**THE CITY OF WINNIPEG WATER AND WASTE DEPARTMENT**  
**REPLACEMENT OF VALVE LRV1 AT MACLEAN PUMPING STATION & RESERVOIR**  
 DETAILS & SECTIONS

**REPLACEMENT OF VALVE LRV1**  
AT MACLEAN PUMPING STATION & RESERVOIR

Submission No. : 1	<b>SUBMITTAL REVIEW</b>		AECOM
Project No. : D265-234-00	Discipline :		
<input checked="" type="checkbox"/> Reviewed - No Comment	<input type="checkbox"/> Reviewed - Revise and Resubmit		
<input checked="" type="checkbox"/> Reviewed - As Noted	<input type="checkbox"/> Review by Consultant Not Required		
<p><small>Review is solely for general conformity with contract. The Consultant does not warrant or represent that information in this submittal is accurate or complete. Review does not relieve Contractor of responsibility for errors/omissions in designs, including this submittal, that are the Contractor's responsibility, and for conforming/correlating with all quantities/dimensions, performing the Work, selecting performance means/methods, coordinating with other parts of the Work/between trades, and performing the Work safely. Notwithstanding this review, Contractor remains solely responsible for contract compliance.</small></p>

**IQ20B4 WT actuator c/w IW9R960 gearbox  
(ON-OFF service)**

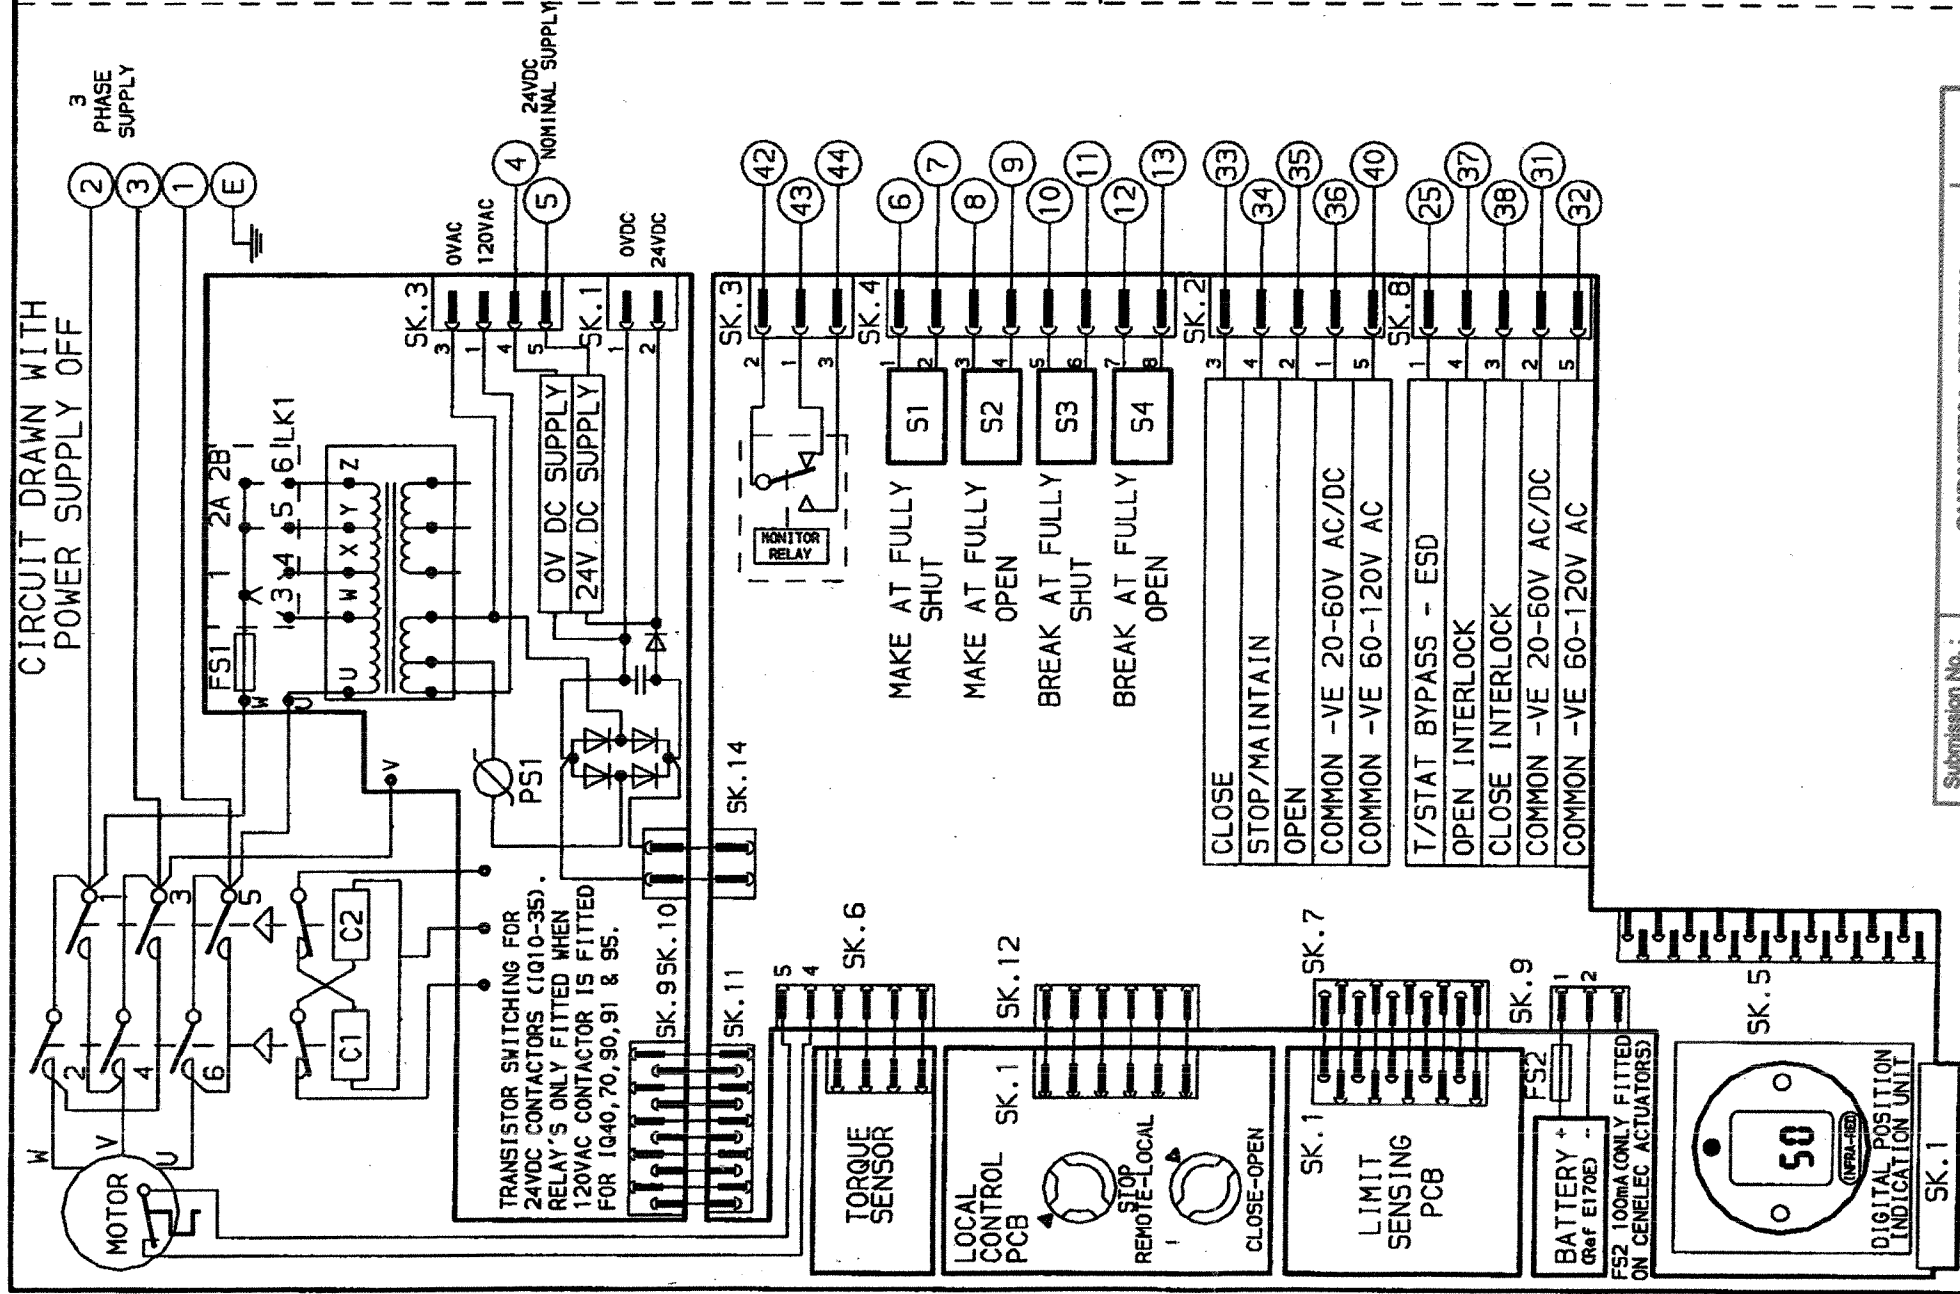
PROVIDE ACTUATOR MOUNTING DETAILS INCL  
ADAPTER PLATES, INPUT & OUTPUT SHAFT DIA'S

Title IQ20, 25 (+IQ520), SHW, IW (MOW) 9RH,			
STANDARD DIMENSIONAL DATA			
Drawn CAD	Checked PRE	Ref Data Sheet	
Date April 04	Job No IQ2SHW_IW9RH

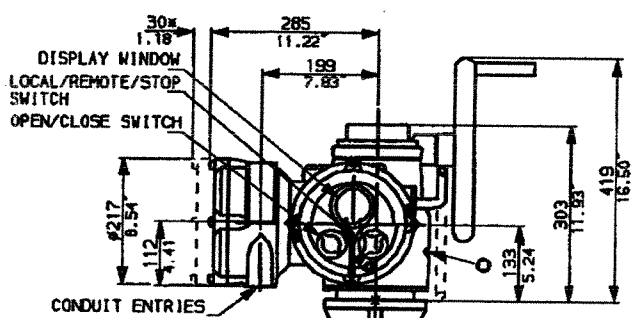
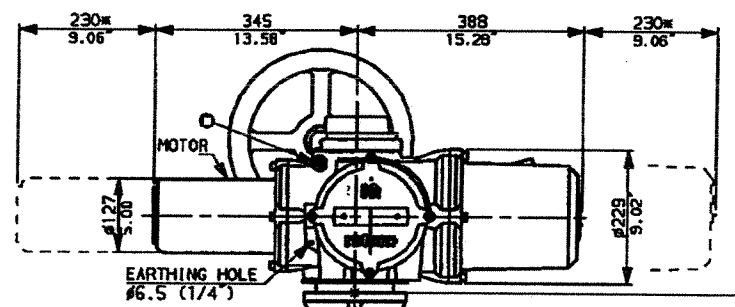
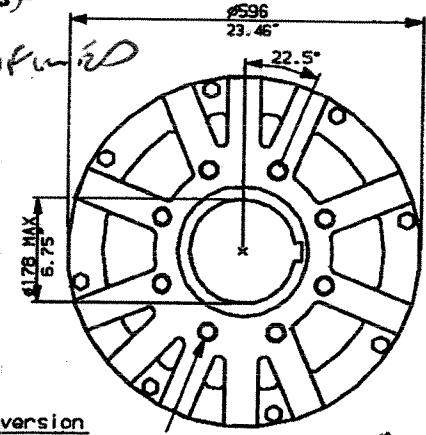
316SS Valve Position Indicator  
 to be fabricated by Mueller Flow Control

*ORIENTATION OF ACTUATOR ON GEARBOX TO BE CONFIRMED*

*CONFIRM  
 EX SHAFT DIA'S +  
 KEY PER TO  
 FAB.*

OUTLINE DETAILS OF IW9  
ISO & USA STANDARD

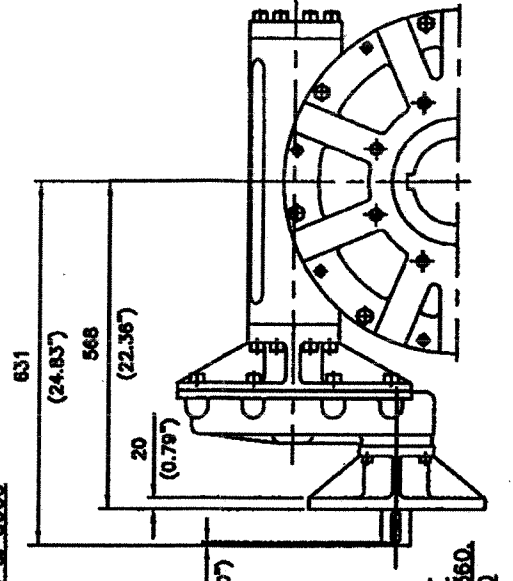
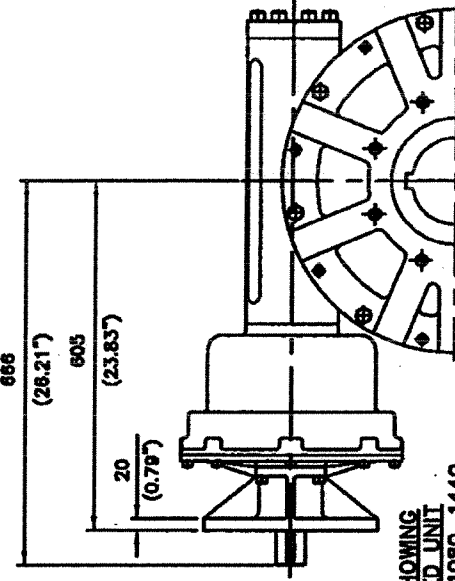
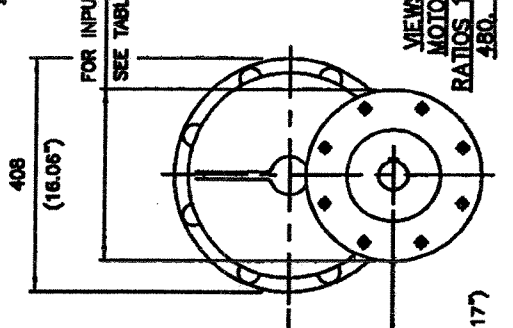
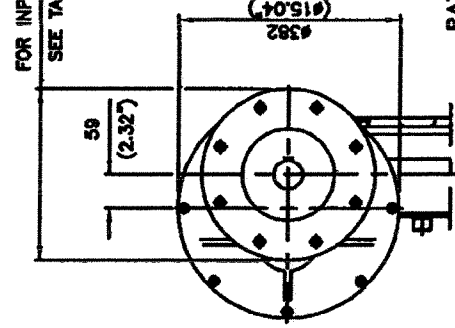
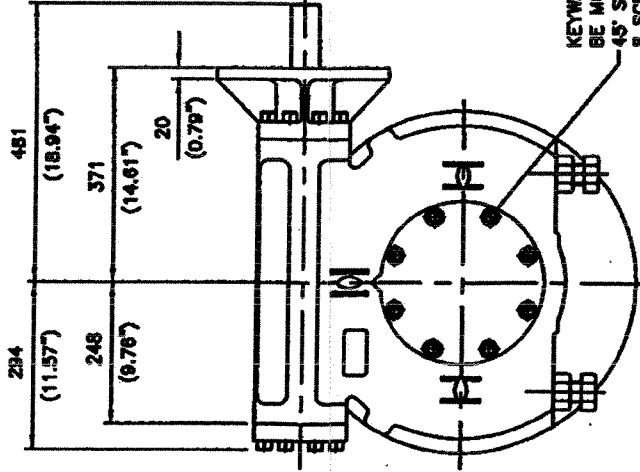
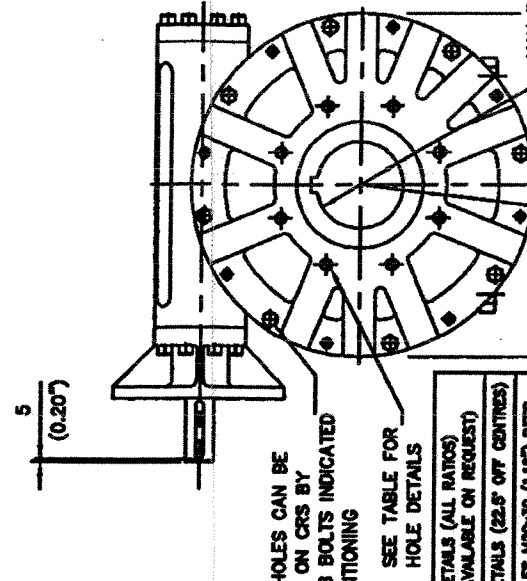
VERIFY  
SHAFT  
ON PLAN  
TO CRASH PLAN
